**Project #21-067
Legacy Landscape Shop
Located at 1221 W 2200 S**

Project Name: Legacy Landscape Shop
Proponent/Owner: Jared Hymas / MTSE Holdings
Project Address: 1221 W 2200 S
Request: Design Review Permit
Current Zoning: Commercial (COM)
Date of Hearing: December 9, 2021
Type of Action: Quasi-Judicial
Submitted By: Tanya Rice, Planner II

Staff recommends that the Planning Commission **conditionally approve** a Design Review Permit for Project #21-067 Landscape Legacy Shop, located at 1221 West 2200 South, TIN# 03-005-0019.

EXTERIOR ELEVATIONS

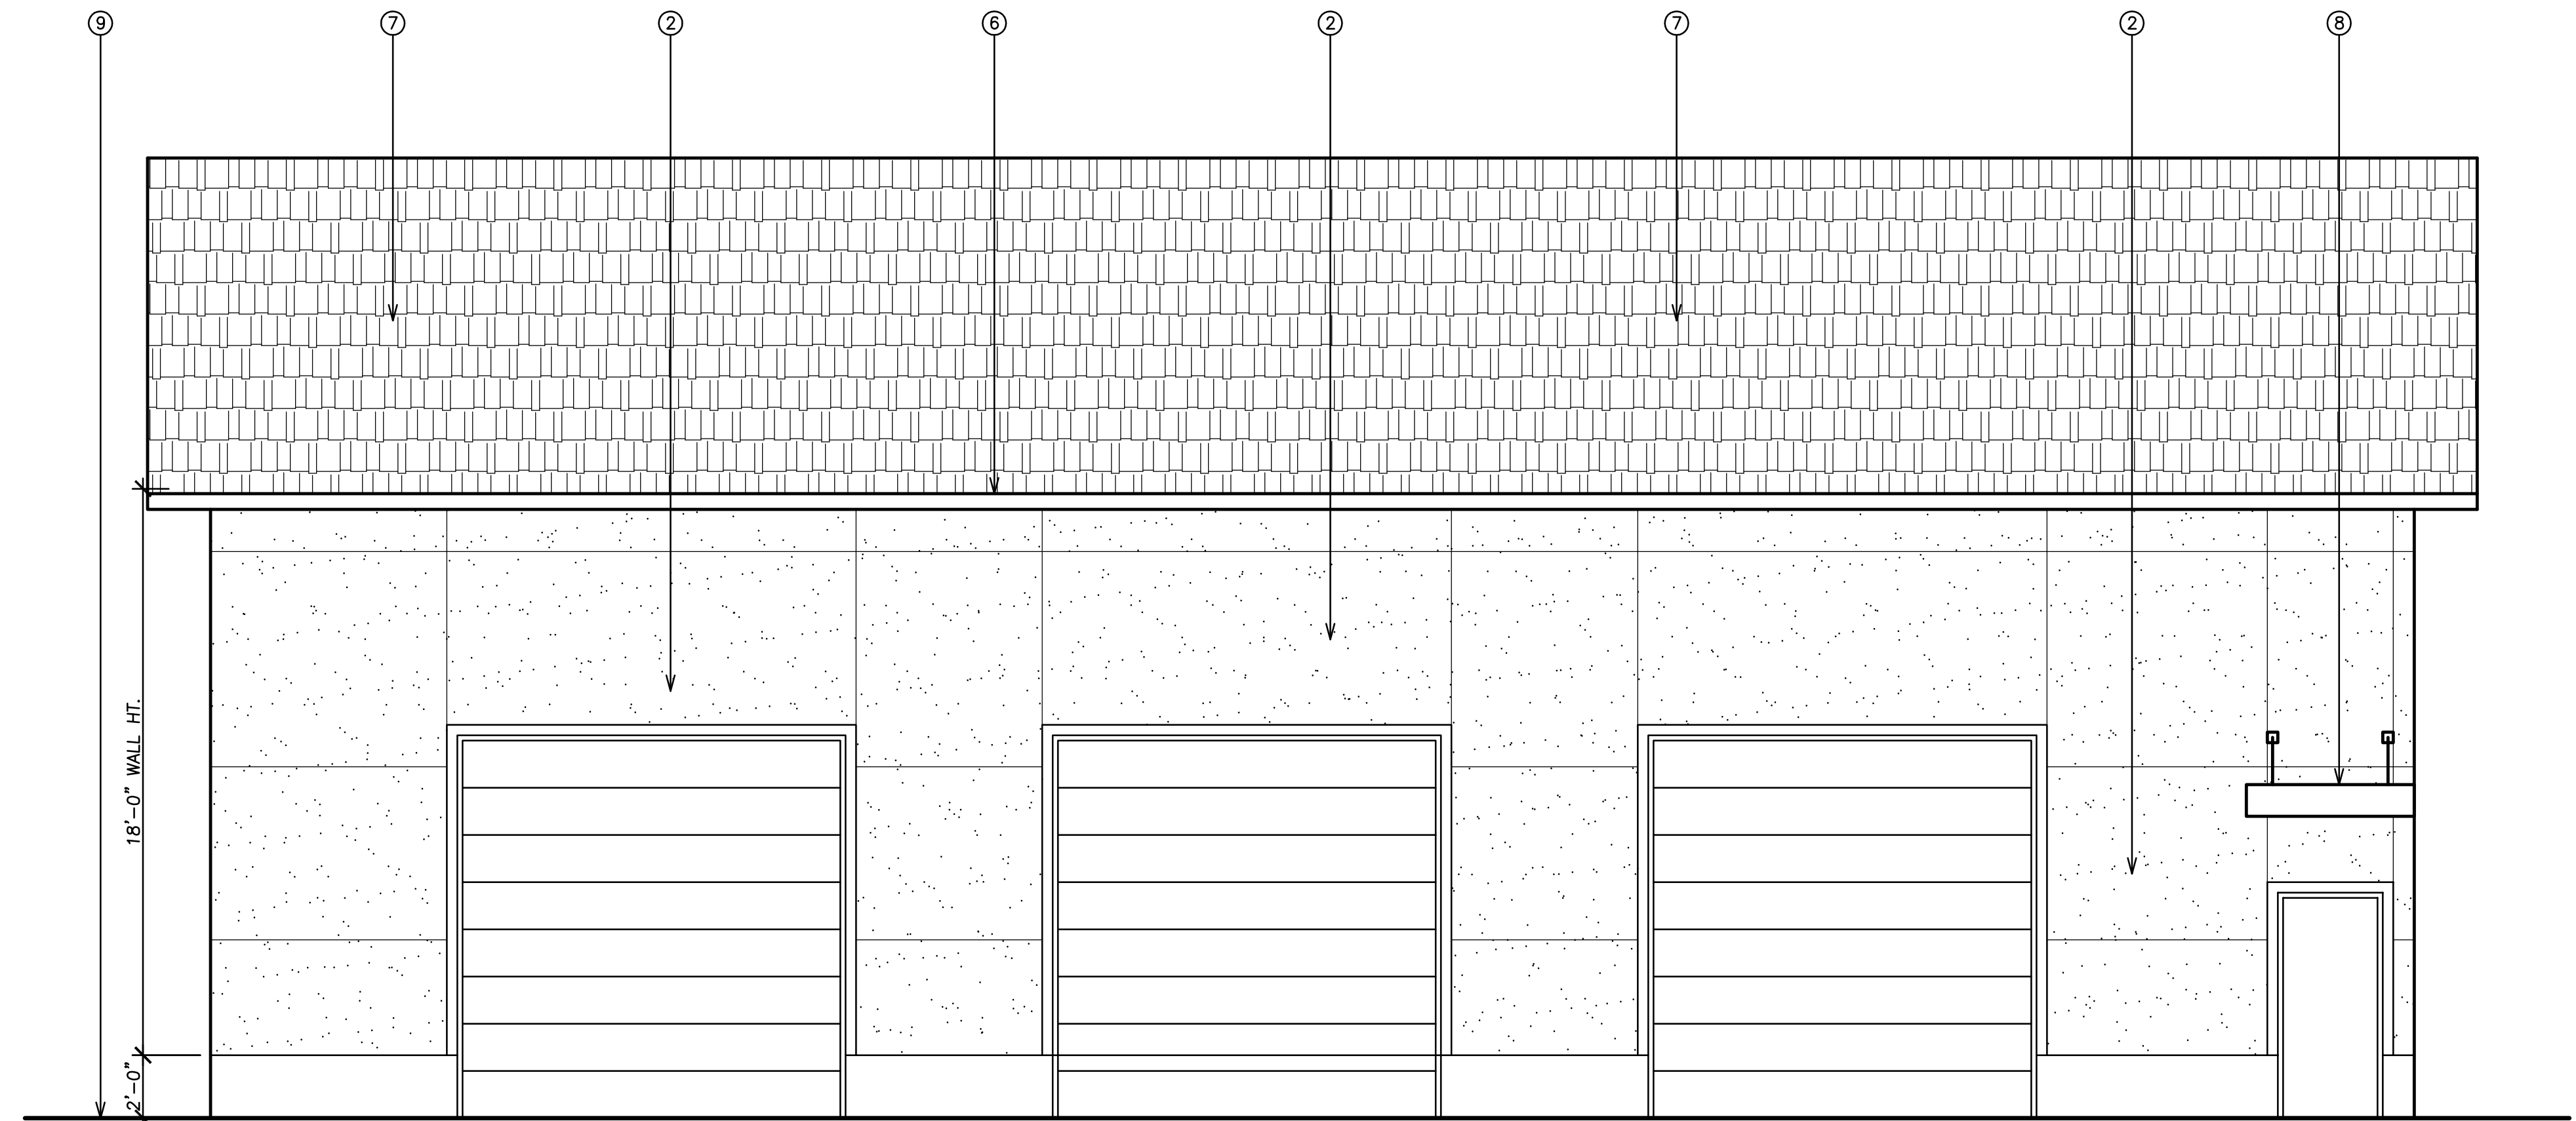
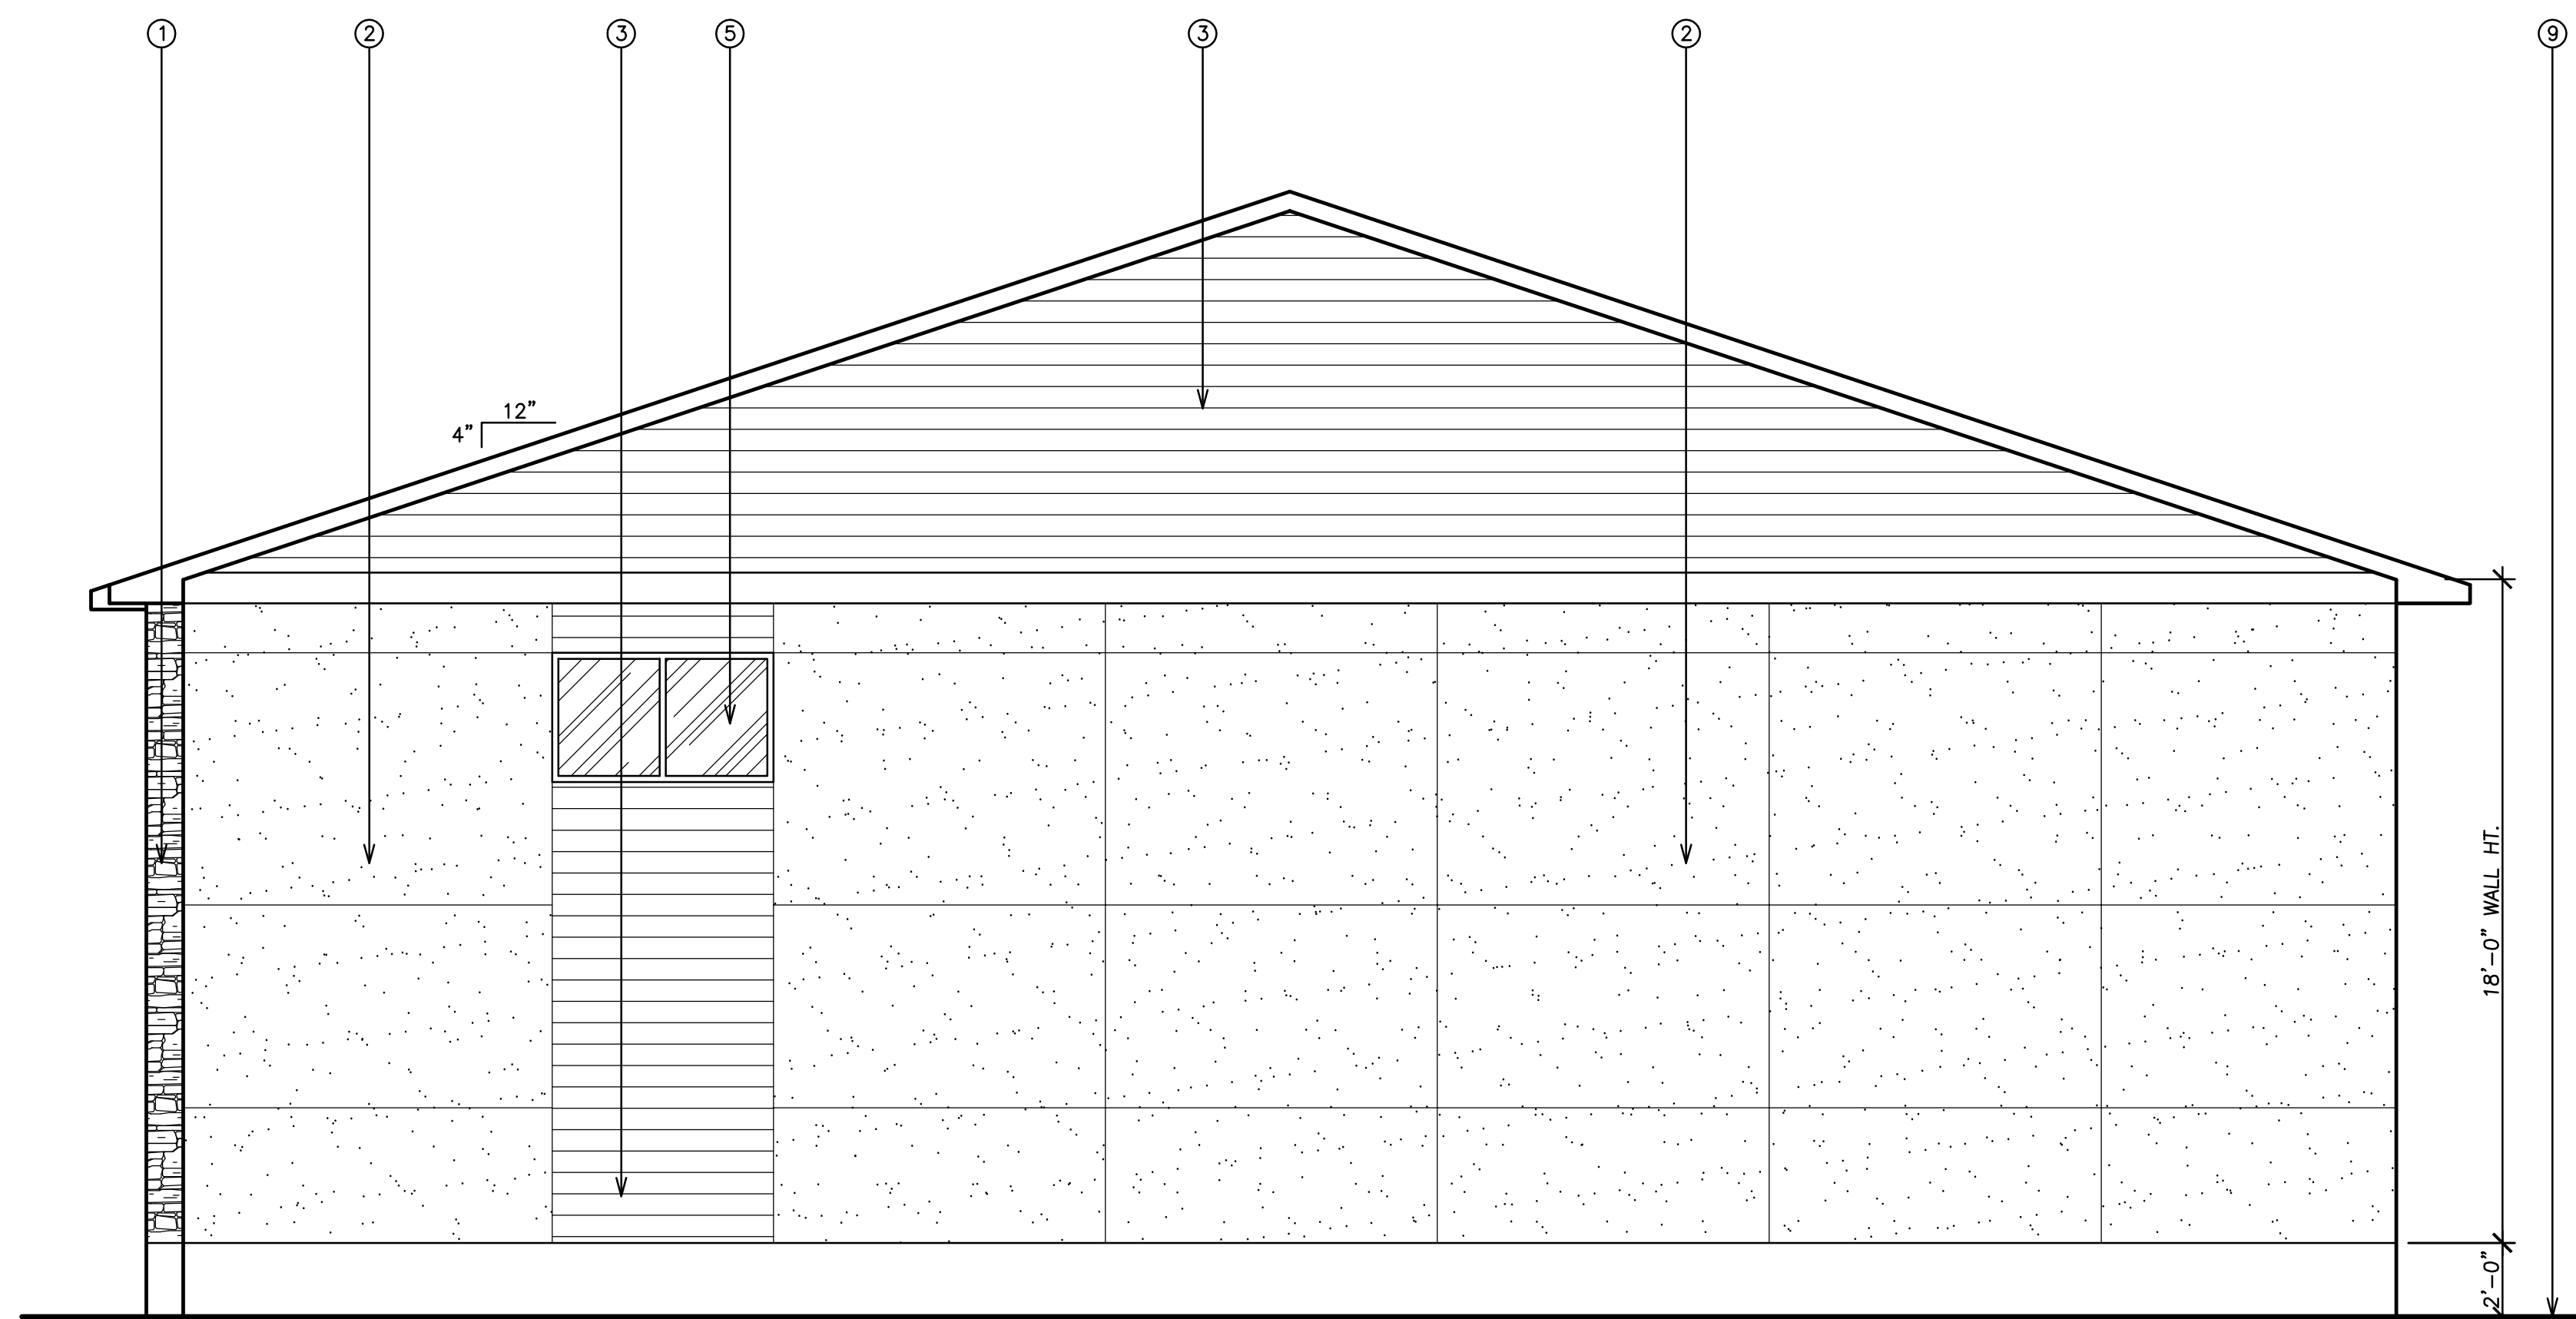
The building design and material distribution around the building lacks 4-sided architectural design. A maximum of 40 linear feet of blank, flat wall is permitted without architectural variation, but the proposal shows approximately 50’ of blank walls on each side elevation. As conditioned, the design standard for this proposal meets the requirements of the LDC.

- c) A total number 10 trees per acre and 25 shrubs/perennials per acre of the final project site shall be provided.
5. The east and west side façades shall have architectural breaks every 40'.
